Tuesday, September 01, 2015 Breckenridge Council Chambers 150 Ski Hill Road

PLANNING COMMISSION MEETING

Re: Work Session on Huron Landing Workforce Housing Project

Subject: Nauman Residence Historic Renovation and Landmarking

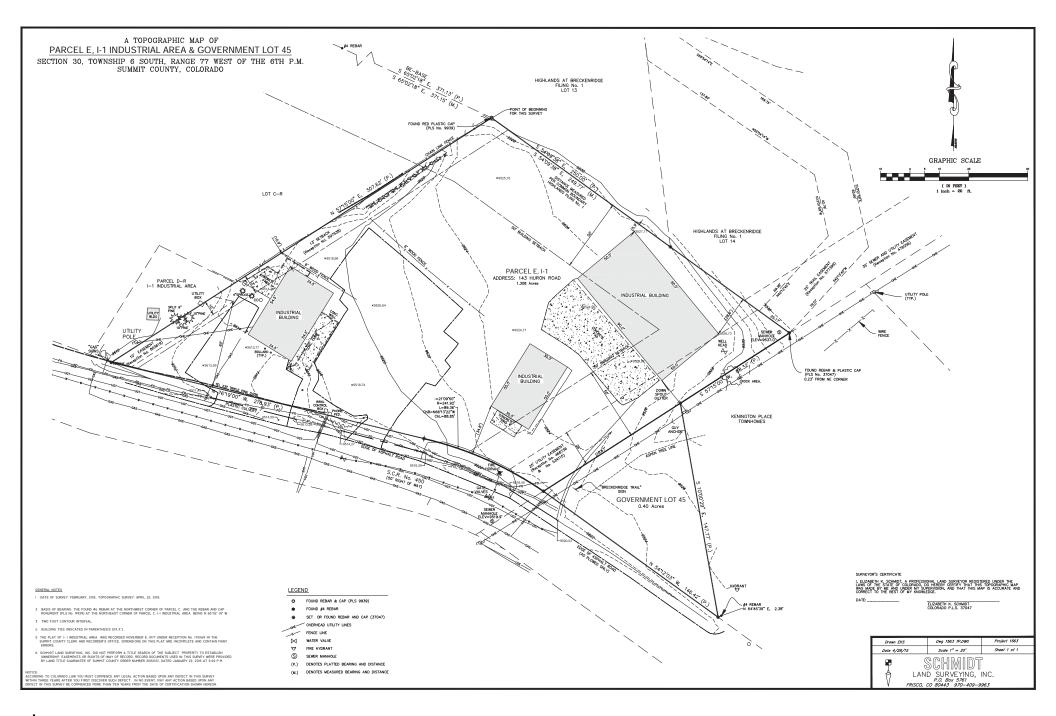
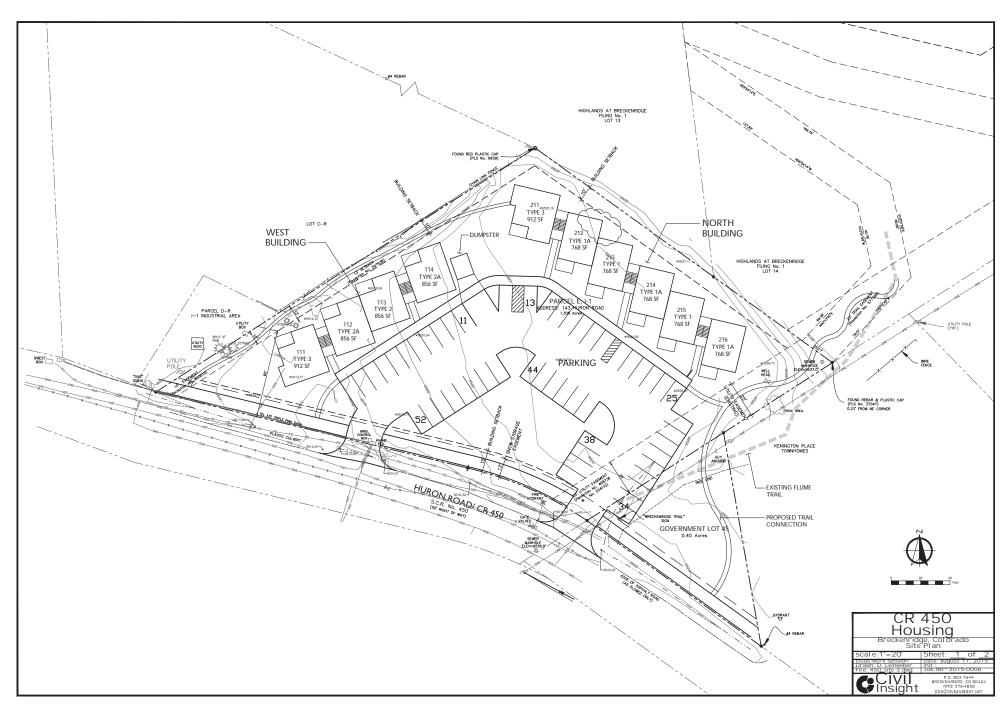
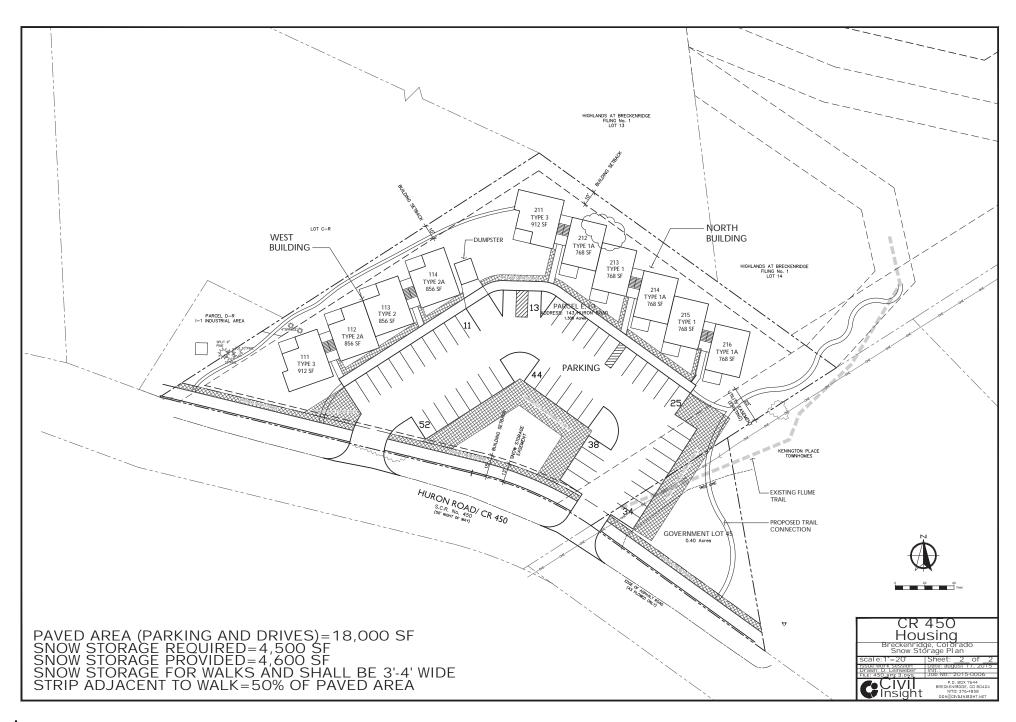
The purpose of the work session is to see if the Planning Commission is satisfied with general direction of the project and is comfortable with Staff's initial interpretation of points. To facilitate the discussion, staff has identified key components of the proposal and Policies where points may be warranted.

POLICY 6 (RELATIVE) BUILDING HEIGHT: (-10) (+1) The proposed project includes two buildings. The west building is 2 stories and the east building is 3 stories, stepping down to 2 stories adjacent to Kennington Townhomes. LUD 5, recommends building heights of 2 stories, therefore negative ten (-10) points is warranted for the east building being a full story above the land use guidelines recommendation (for a total of x feet). As mentioned above, the east building is designed to step down to two stories adjacent to Kennington Townhomes, Policy 6R encourages buildings to step down along the edges. Staff is recommending ten negative (-10), and one (+1) positive point under this policy. Does the Commission concur?

POLICY 9 (RELATIVE) PLACEMENT OF STRUCTURES: (-3) The proposal meets all absolute setbacks and the relative setbacks on three sides but is less than the recommended 15 feet to the rear property line. Designing the structure to encroach on the rear relative setback was done to provide greater separation from the front parking area without having any significant impact to the adjacent backdrop of the undeveloped hillside. Staff recommends negative three (-3) points under Policy 9R. Does the Commission concur?

POLICY 16 (RELATIVE) INTERNAL CIRCULATION: (+3) The plan proposes constructing a section of recreation path fronting Huron Road. Huron Road has been regularly identified as weak spot in our bicycling and pedestrian network. Completing this section of recreation path will benefit the residents of this development and provide a safer means of non-auto travel between the heavily populated areas in French Creek and French Gulch and Town. Most recently Pinewood Village II was awarded three positive (+3) points under Policy 16R for providing a sidewalk connection. Staff recommends positive three (+3) points under Policy 16R. Does the Commission concur?

Staff would like Planning Commission input on the draft point analysis and would also look for any additional comments or concerns before this project moves forward to a preliminary hearing.

EXISTING FLOOR PLANS

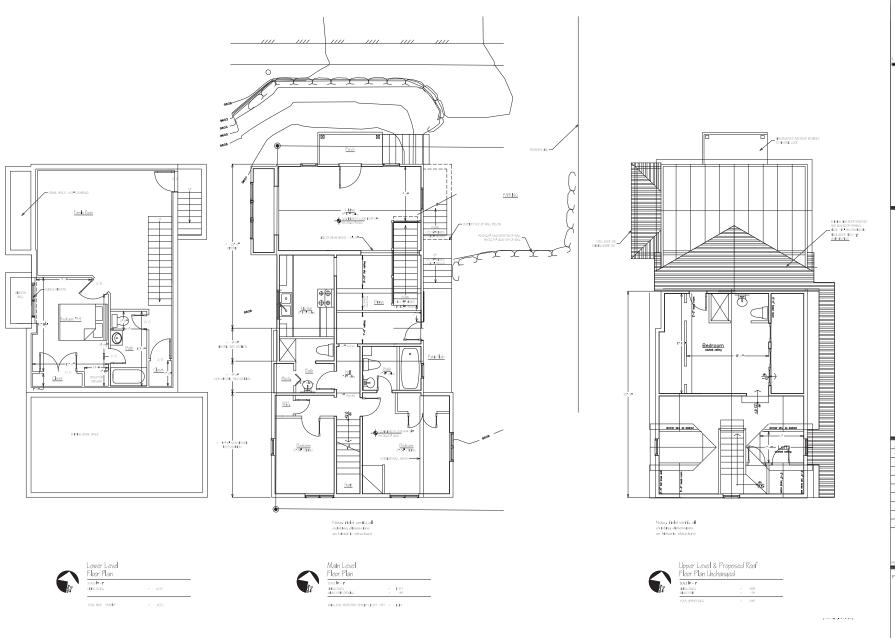
The more recent, non-compliant addition was constructed in the 1980's. This addition was partially constructed over the west property line like the historic house. It encapsulates the shed addition that was added to the south to house a kitchen and bathroom. Portions of that exterior wall and roof edges are visible today. Because of the setbacks, these additions are now classified as a legal nonconforming structure. As legal a nonconforming structure, no changes or increase in nonconformity are proposed. These additions are illustrated on Sheet A2, Elevations, of the attached plans.

Placement of Structures (9/A & 9/R): There is no proposed change in the location of the footprint of the house. As it exists today, the front porch encroaches into the Washington Avenue ROW and the historic bay window encroaches into the west alley ROW. Also, a small portion of the non-compliant addition encroaches into the west alley ROW. An encroachment license agreement will be processed prior to issuance of a building permit for the existing encroachments of the historic house, and has been made a Condition of Approval.
